ACCESS REPORT

DEVELOPMENT APPLICATION

639 GARDENERS ROAD MASCOT

COMMERCIAL DEVELOPMENT (INTERNET EXCHANGE FACILITY)

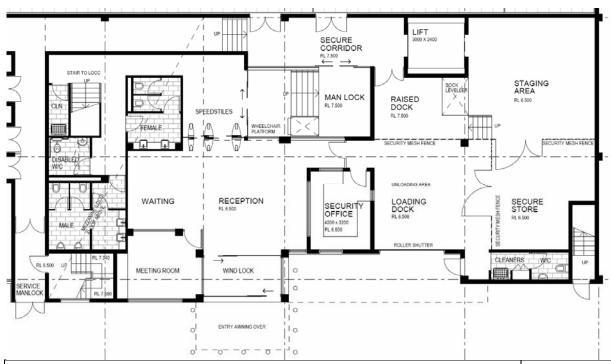
BCA Compliance	Complies
1.	The development shows the ground floor entry level of @RL6.500 with the adjoining carpark and Church Street entry at approximately RL6.200-6.400.	YES
2.	The access route proposes a 1:25 maximum graded walkway from the property boundary @RL6.200 to reception entry @RL6.500 thereby demonstrating the walkway will comply with Part D3.2 of the BCA in terms of enabling access from an adjoining public footpath to the principle building entrance.	
3.	The main doorway entrance to the building demonstrates appropriate doorway circulation space while the doors will be documented at construction certificate stage to confirm compliance with Part D3.2 of the BCA.	YES
